Access Compliance Report

Public Rights-of-Way

(Curb Ramps)

Intersection ID: 31563	Main Street: DORIS_RAY_CT	Cross Street: MCCORD_ST	Location: SW
ADA ID: 6AE031CC697D	Ramp Type: Perp	Initial Pass/Fail: Fail	Overall Compliance: No
Severity Score: 22.5			
Codes/Mitigation Info/Possible Solution		Field Measurements/Component Compliance

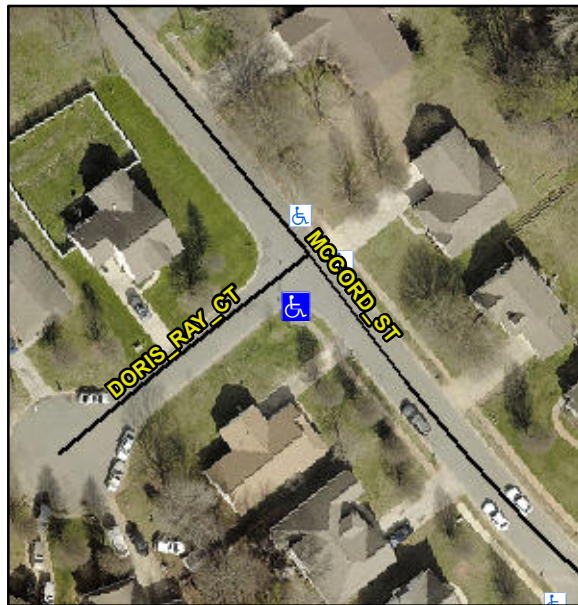
R304.5.1, R304.2.2, R304.5.3

Compliance	Description	Data	Compliance	Description	Data
N/A	Ramp Length (in)	49.0	No	Ramp Slope (%)	9.9
No	Ramp Width (in)	43.0	No	Ramp XSlope (%)	4.1
N/A	Flare Type LT	N/A	N/A	Flare Type RT	N/A
N/A	Flare Slope LT (%)	N/A	N/A	Flare Slope RT (%)	N/A
N/A	Flare Traversable LT?	N/A	N/A	Flare Traversable RT?	N/A
N/A	Landing Length (in)	N/A	N/A	DWS Provided?	N/A
N/A	Landing Width (in)	N/A	N/A	DWS Contrast?	N/A
N/A	Landing Slope (%)	N/A	N/A	DWS Length (in)	N/A
N/A	Landing X Slope (%)	N/A	N/A	DWS Full Width?	N/A
N/A	Landing Curb? (Y/N)	N/A	N/A	DWS Offset (in)	N/A
N/A	Shared Landing?	N/A			
N/A	Gutter Ponding?	N/A	N/A	Gutter Slope (%)	N/A
N/A	Gutter Lip Ht (in)	N/A	N/A	Gutter X Slope (%)	N/A
N/A	Painted X Walk1?	No	N/A	Painted X Walk2?	N/A
	X Walk 1 Direction	To E		X Walk 2 Direction	N/A
N/A	X Walk 1 Width (in)	N/A	N/A	X Walk 2 Width (in)	N/A
	X Walk 1 Slope (%)	2.4		X Walk 2 Slope (%)	N/A
	X Walk 1 X Slope (%)	0.9		X Walk 2 X Slope (%)	N/A

Remove & Replace Entire Ramp.
